MEMORANDUM

PLAN NAME: Downcounty Consortium School #29 (McKenney Hills)

PLAN NUMBER: MR2010720

PLAN TYPE: Final Forest Conservation Plan

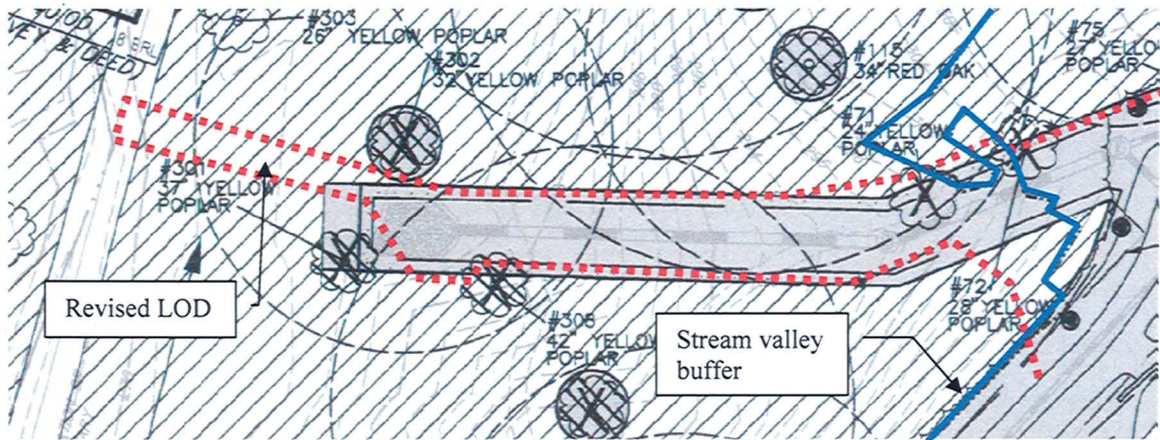
The final forest conservation plan (FCP) differs from the approved preliminary forest conservation plan in two main regards.

- A sewer line was added to provide a gravity sewer, which increases the amount of forest clearing in the stream valley buffer.
- There are additional impacts to some specimen trees due to the addition of the sewer line and the detailed development process. There are also some specimen trees that were previously affected by the plan that are no longer being impacted.

FINAL FOREST CONSERVATION PLAN
 DOWNCOUNTY CONSORTIUM ES #29
 2600 HAYDEN DRIVE, SILVER SPRING, MD. 20902

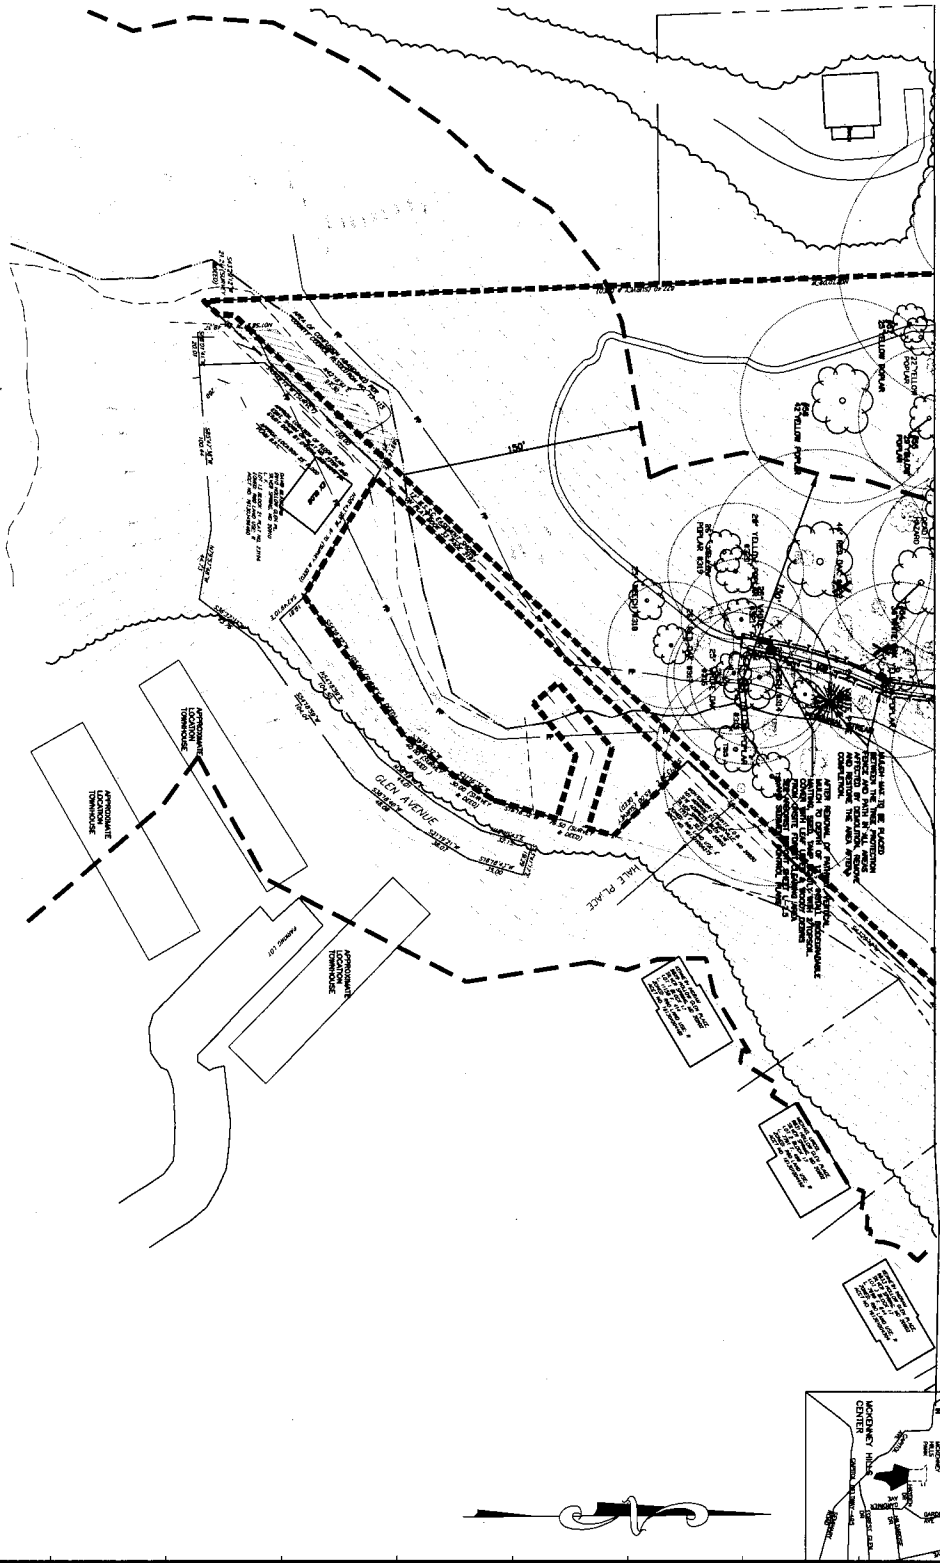
What precisely is going on with the changes on the FFCP map, specifically the designation "additional area adjacent to buffer to mitigate encroachment = 0.03 Acres"? It appears that a greater level of intrusion into and destruction of the forest is planned than was indicated in the FCP. What exactly is being proposed in this instance?

Why have these negative changes, i.e. the removal of 9 additional trees that were not designated for removal in the FCP been incorporated into the FFCP? Are such changes not subject to additional Planning Board review?

It would seem that as a result of the implementation of this language there would be far less disturbance in the area around the steps than was likely to have occurred under the FCP. Why has there not been a positive improvement in the status of the trees in this area that is shown on the FFCP? Is it not logical to expect that there should be a positive impact as a result of the application of this language in the context of the FFCP that would result in far fewer trees being negatively impacted and removed? Instead there is either no change or the changes that have been indicated go the other way, i.e. to greater impacts and more tree removal. This is illogical. These questions need to be answered.

Inside the LOD at the southern boundary in the FCP only a drawing showing a connection with a mulched or natural trail outside the LOD was shown. Now in the FFCP this trail has been turned into a concrete sidewalk that is now shown as continuing inside the LOD where it links up with a “paved trail to property line”.

This appears to indicate that there will be a point of access here allowing entrance and exit from the site into the woods around the Milton house. Its this a correct interpretation of this point? If not, what is the correct interpretation?

There is no mention of the concrete sidewalk inside the LOD linking up with the path outside in the MOU. What are the details on this possible access point are missing from the FFCP? What is the intent of this feature of the site? Does that intent conflict with any aspect of the decision of the Planning Board?

A lightly hatched line that appears on the FCP that runs from inside the LOD to outside at an angle to the LOD has been changed in the FFCP into a bold, black line. In the legend of the map, the bold, black line is supposed to represent a property boundary. What does it represent here and why has there been a change from the FCP to the FFCP?

It is not clear what the designation "Additional Area Adjacent To Buffer To Mitigate Encroachment = 0.07 Acres" means. This point needs to be clarified. This change needs to be assessed in terms of whether it will or will not affect any significant or specimen trees more than the FCP initially called for.
